**MODIFICATION REQUEST:  
Commercial Building C3, Barangaroo South  
MP 11\_0044 MOD 3**

Secretary's Environmental Assessment Report  
Section 75W of the  
*Environmental Planning and Assessment Act 1979*

December 2015

**Figure 4:** façade design originally proposed in MOD 3 (left) and amended design proposed in PPR (right).

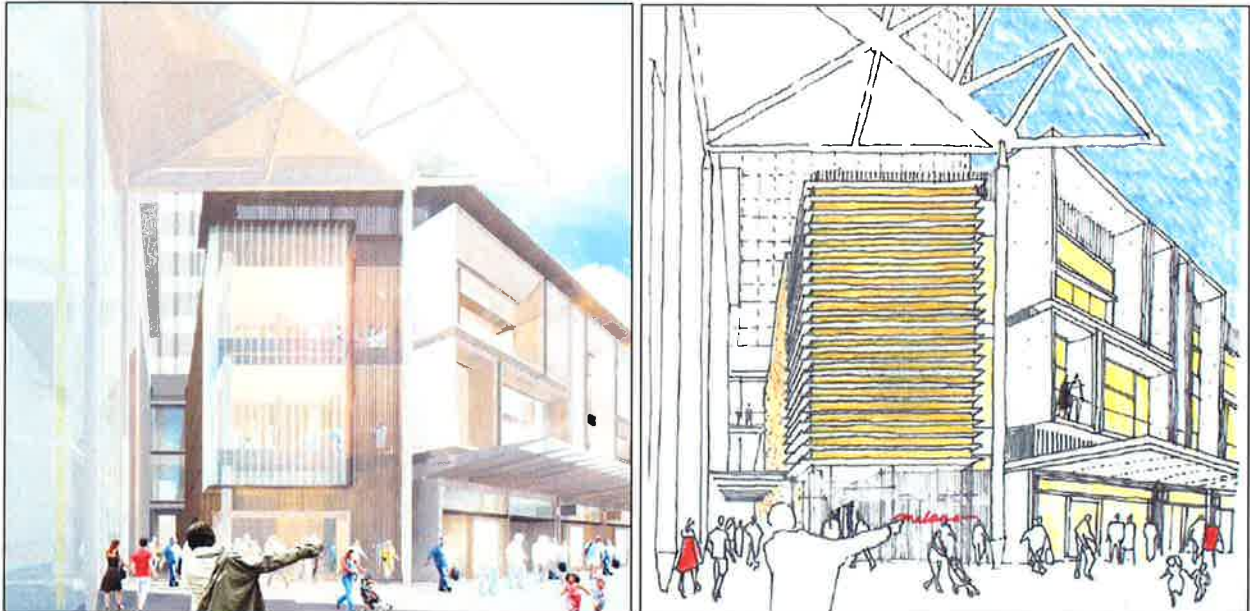
- Awning Design:
  - to amend the design to resolve concerns in relation to the environmental exposure of the ground floor retail spaces by lowering the awning soffit height from 4.4 to 3.7m; and
  - to amend the design to a more conventional, solid structure incorporating retractable folding arm awning that can be concealed when not required by retailers.
- Façade Design:
  - to refine façade design associated with the proposed north-east extension of the western lobby. It is proposed to replace the vertical glass fins in the façade with horizontal glass panels as illustrated in **Figure 4** below.
- Podium cornice detail: to remove the cornice detail at the top of the podium. Instead it is proposed to extend the window features or surrounds as illustrated in **Figure 5** below.

**Figure 6:** Proposed interchangeable ground floor shopfronts.

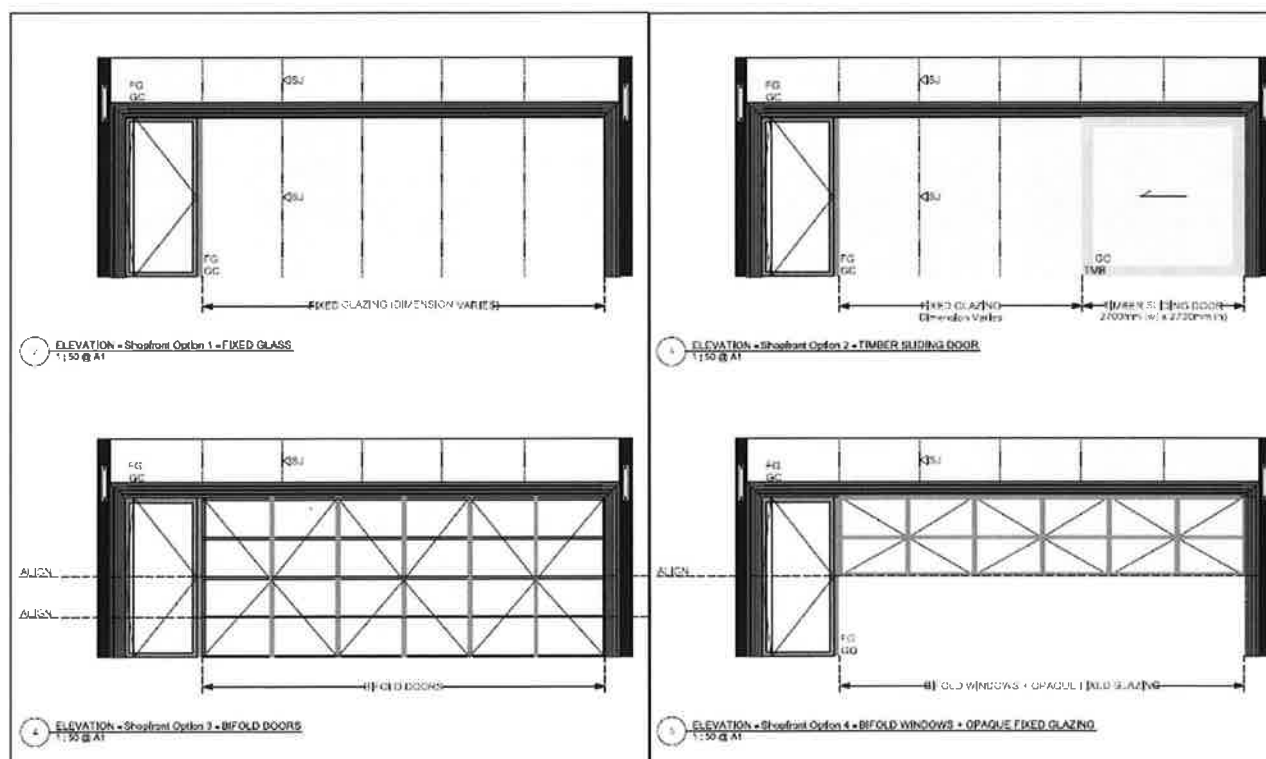
The application seeks approval to introduce four shopfront typologies which have been developed to provide flexibility with the shopfront design whilst providing a unified design approach. Shopfronts are located on all four elevations of the building podium of C3. The proposal seeks to introduce flexibility for the future tenants through the potential to utilise the fixed glazing, single pivot opening doors (2 types) or retractable doors which are interchangeable within the structural frame of the podium, as detailed in **Figure 6** below.

The Department considers that the design of the proposed shopfronts will provide a high quality outcome and will complement the approved podium design of C3. In particular, the shopfront designs will enable the retail tenancies to integrate with the surrounding public domain through the potential use of bifold retractable and sliding doors, thereby contributing to the activation of the public domain. Furthermore, this design strategy will enable a consistent and integrated design approach to the retail tenancies within the podium. This aspect to the proposal has been supported by Council (**Section 4.2**).

In order to ensure a consistent approach to the design resolution of the shopfront in C3, it is recommended that a condition consistent with the requirements for C4 and C5 apply in this instance. Subject to compliance with this condition, the Department supports this aspect of the modification application.

**Figure 11:** Proposed modifications to ground floor plan

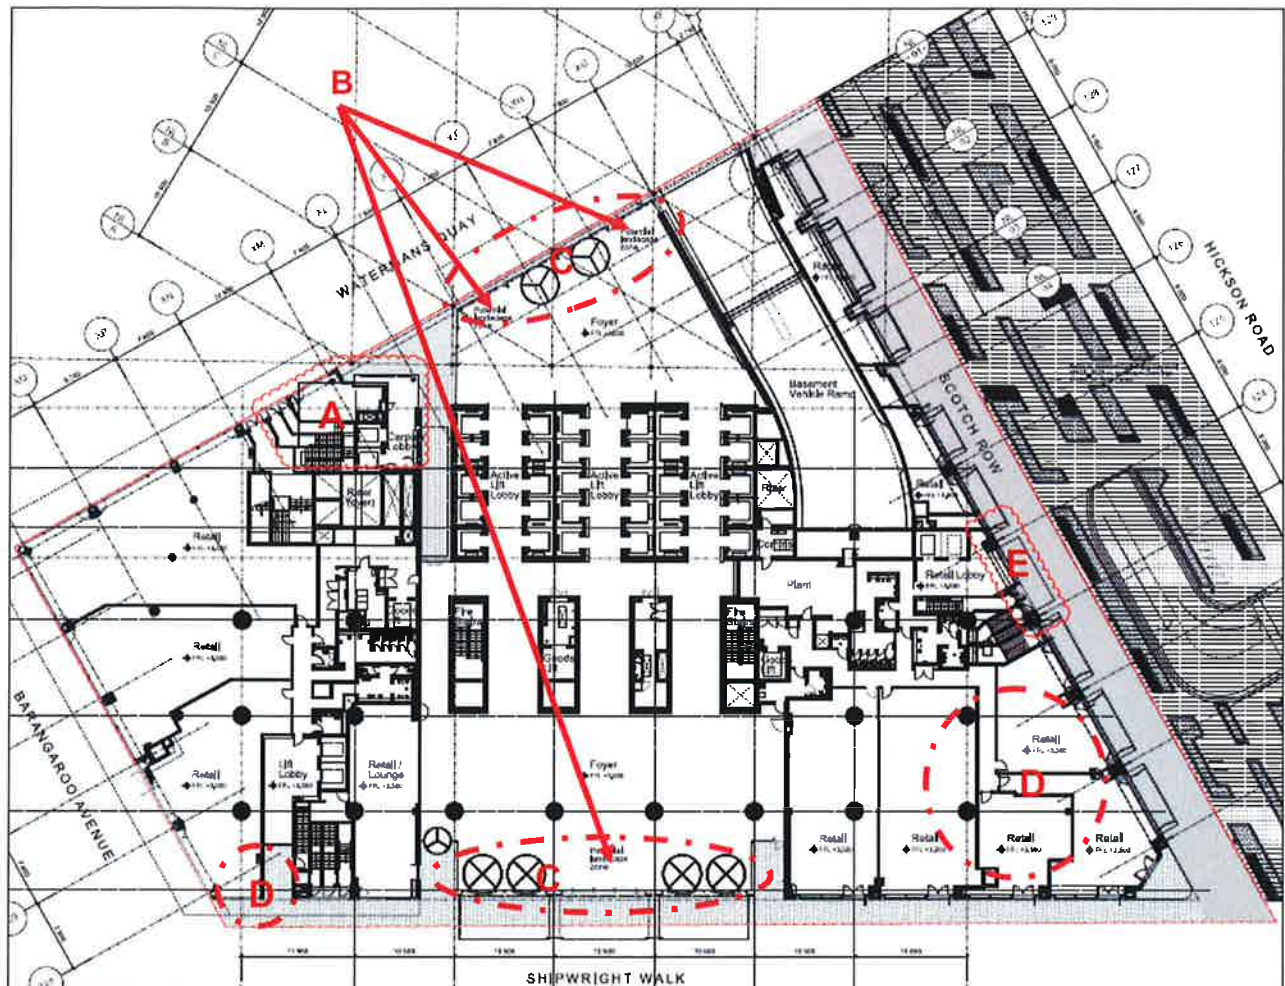
With reference to **Figure 12** below, the Proponent proposes a number of design changes to the ground floor level of the building, including the following:

- the north-east extension of the western lobby (marked 'A' on **Figure 11**);
- the potential for lobby planters to be integrated into the lobby design (marked 'B' on **Figure 11**);
- adjustments to the design of the foyers on the north and south elevations, including the lobby entrances, shading and awning details (marked 'C' on **Figure 11**, also refer to **Figures 12** and **13** below);
- minor changes to the retail tenancy configurations (marked 'D' on **Figure 11**); and
- new awning on Scotch Row to denote the retail lobby (marked 'E' on **Figure 11**)

The Department has assessed the design implications of the above modifications and concludes that these modifications are generally minor in nature and will contribute to the design quality and functionality of the ground floor level of the building. The Department notes that the introduction of the planters is also consistent with the design detail approved for Commercial Buildings C4 and C5. For these reasons, the Department supports these modifications.

**Figure 12** Approved northern east elevation showing North Lobby resolution

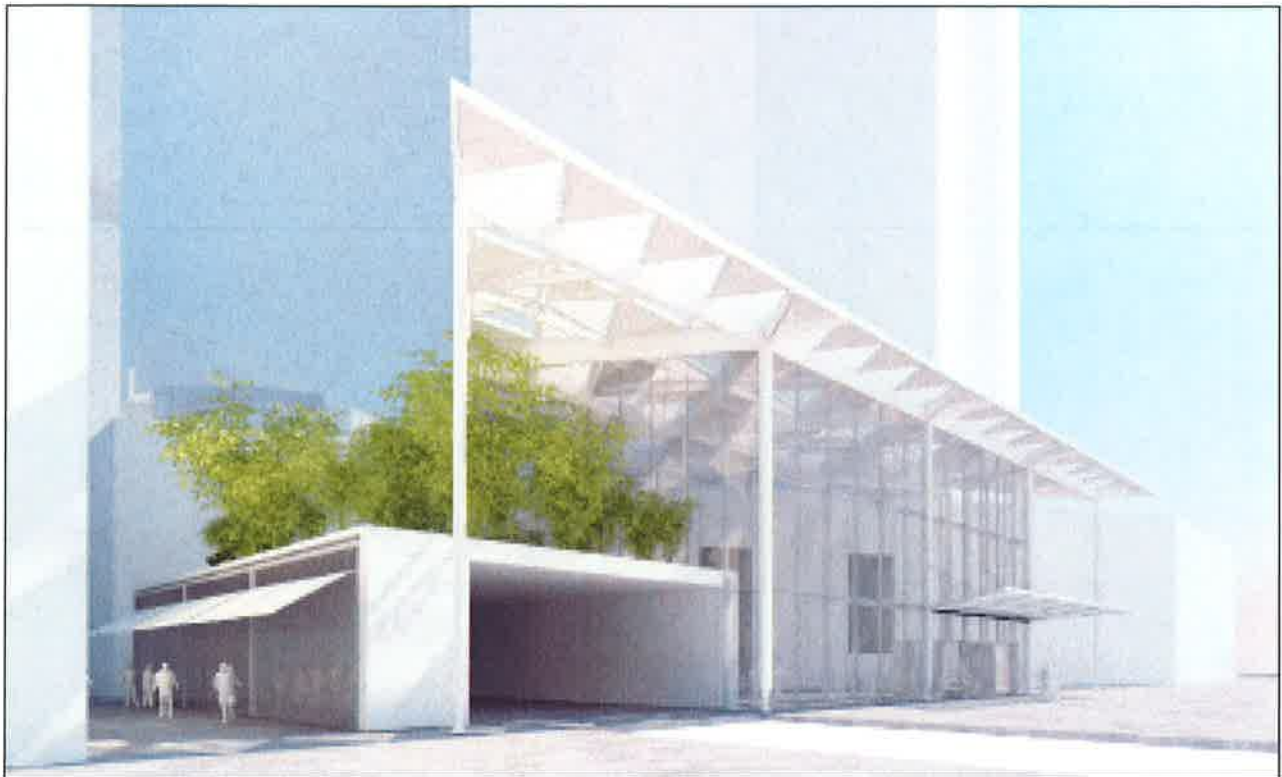
The refinement of both North Lobby and South Lobby represent the most significant changes at the ground floor level of the building and are illustrated in **Figures 12 to 15** below. It is evident from these comparison figures that the design has been refined and simplified.

**North Lobby:** As illustrated in **Figures 12 to 13**, MOD 3 proposes the further design refinement of the North Lobby. Specifically, the awning design has been refined, additional sun-shading has been provided above the awning level, and the geometry and design of the roof over the lobby has been revised and extended as an open structure over the first floor terrace to the east on Shelley Lane (**Figure 13**).

**South Lobby:** In relation to the South Lobby, MOD 3 represents a reconsideration of the entry detail in terms of the lobby's alignment, the form of the entry awning and the overall architecture of the entry. The design has been simplified and now represents a more conventional lobby entrance when viewed from the public domain. Whilst the Department considers the MOD 2 design to be more dynamic and sculptural in its form (**Figure 14**), the design proposed in MOD 3 (**Figure 15**) remains acceptable and represents a well-considered design solution which will also sit comfortably with the architecture and composition of the south elevation of the building podium.

The Department considers that the revised design is well resolved and complementary to the overall architecture of the north elevation of the podium. In addition, the extension of the solid walls to define the entry to the car park are considered to provide an acceptable architectural treatment.

Figure 17: North/west awning detail

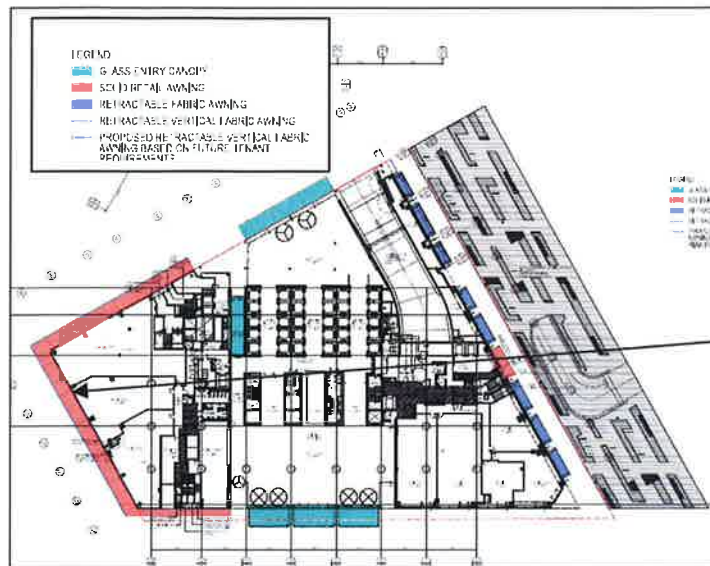
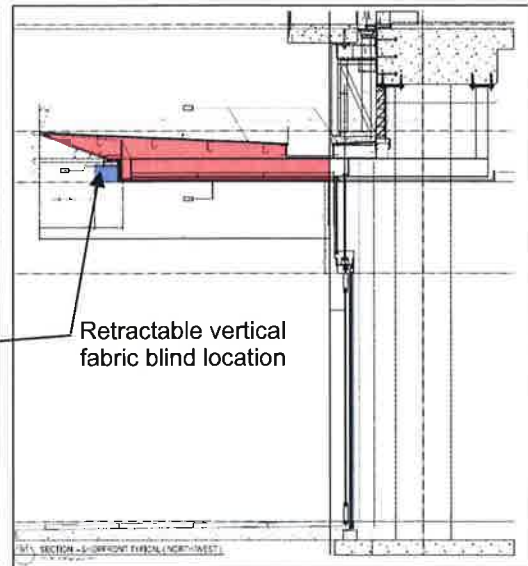
The approved design of the west podium includes a permanent structure at the awning edge supporting roll-down butcher blinds, in order to address western exposure. MOD 3 proposes to reduce the approved awning soffit height on the western side of the podium from approximately 4.4 to 3.7 metres. The design of the awning is also proposed to be modified and simplified to incorporate the retractable fabric awning that can be concealed when not in use (refer **Figure 16** and **17**). The Proponent has confirmed that the blind would have a maximum vertical drop of 1.3 metres. The Department finds the design for the retractable blinds to be acceptable and notes that its limited vertical drop will ensure that there is sufficient activation of the facades and integration with the public domain whilst enabling environmental control.

**Figure 19:** Proposed Level 3 podium design

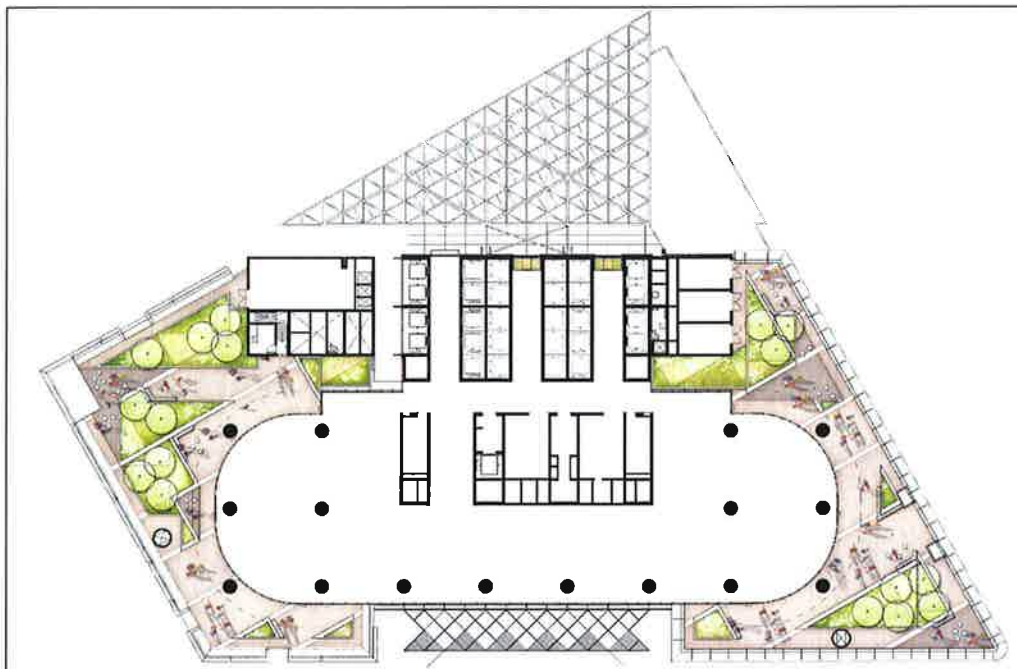
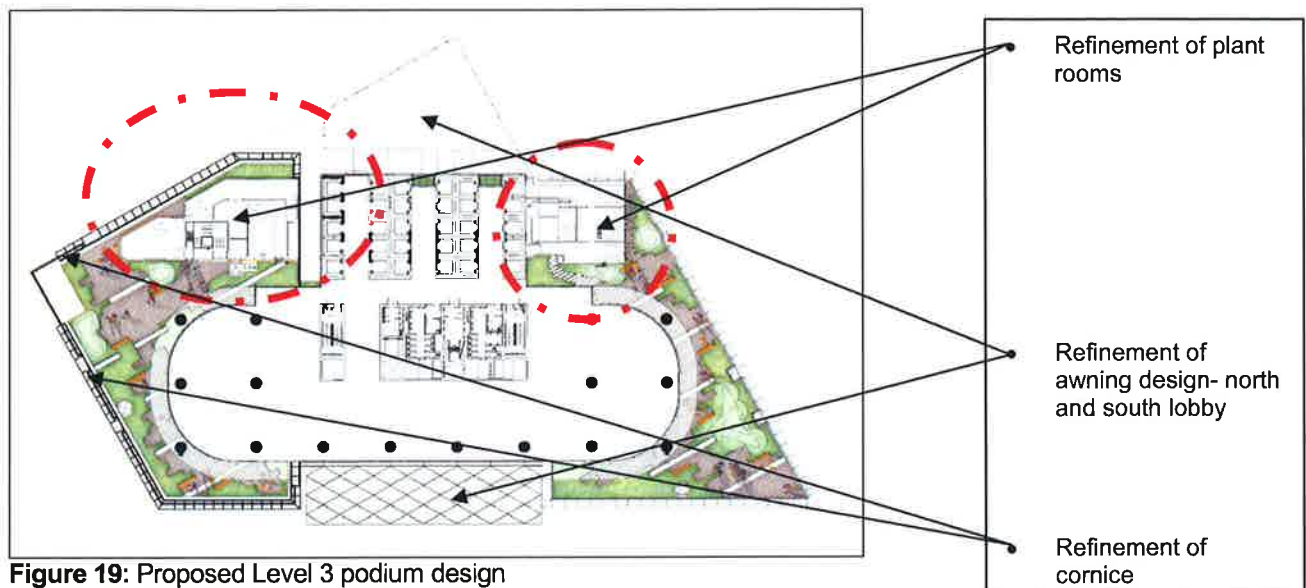
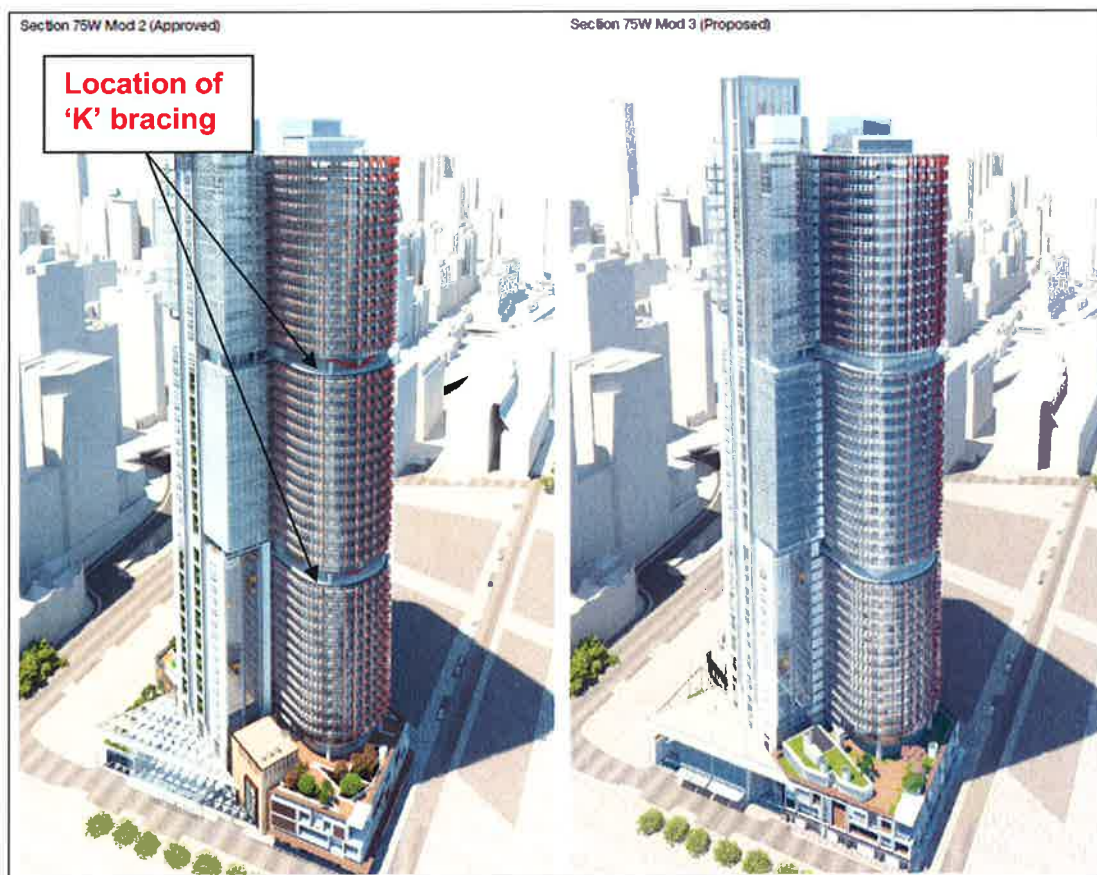
The application proposes the refinement of Level 3 of the building which forms the podium rooftop level of C3. The changes include the refinement of the building plant design and the rooftop landscaping (**Figures 18 and 19**). In addition, the application details the refinement of the cornice and the entrance roof to the North and South lobbies, as discussed above.

The Department notes that whilst the change to the cornice design on the north-western corner of the podium (as discussed above) results in the plant room being visually more prominent from the public domain (**Figures 8B and 9B**), the Department considers the plant rooms to be well designed and suitably integrated into the rooftop landscaping to reduce their visual impact. On balance, these modifications are not considered to diminish the design quality of the building and are supported by the Department.

**Figure 21:** Proposed resolution of rooftop levels of the building. Approved design (MOD 2) at the top and proposed design (MOD 3) below.

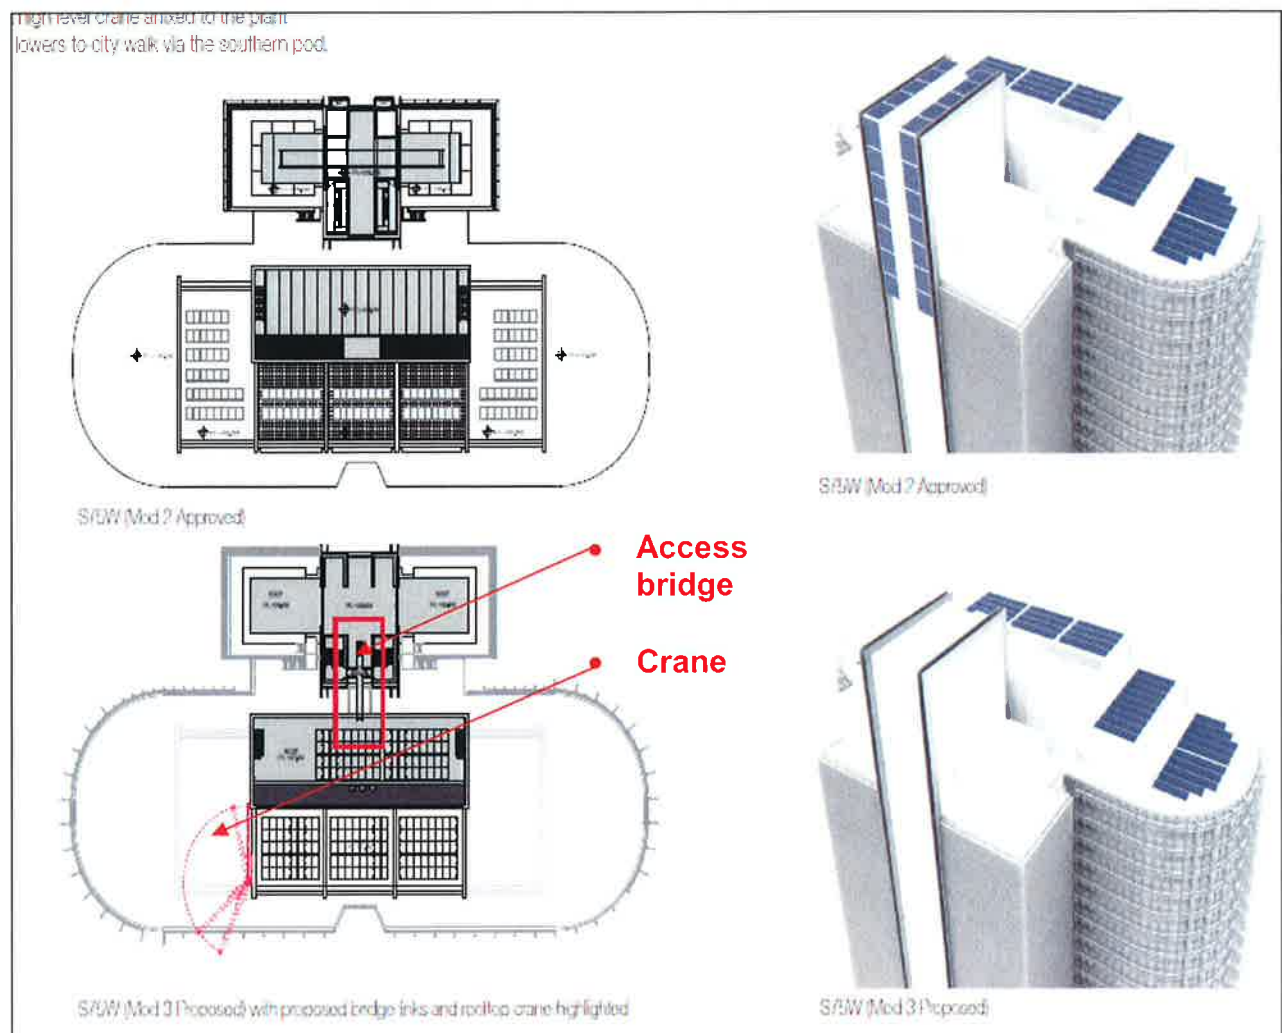
Modifications to the rooftop levels (over Levels 49-52) are limited to minor adjustments to the plant terrace areas and the redesign of the access arrangement to the building plant to include new rooftop bridge links (**Figure 21**). A transformer crane is proposed at the rooftop level of the building and will have a maximum height of RL 208.1. The crane will therefore be below the maximum permissible height of RL 209 which applies to Block 3 pursuant to the MD SEPP and the Barangaroo Concept Plan approval.

The most apparent change to the visual appearance of the rooftop of the building is the removal of the photovoltaic cells from the northern core, as illustrated in **Figure 21** below. The Proponent has advised that this change will not impact on the buildings environmental performance and ability to meet the stated ESD targets.

Based on the minor nature of these modifications, the Department concludes that modifications will not result in any increase the bulk and scale of the building termination and would not result in any discernible additional environmental impacts when compared to the existing approved development. Therefore, the Department supports this aspect of the proposal.
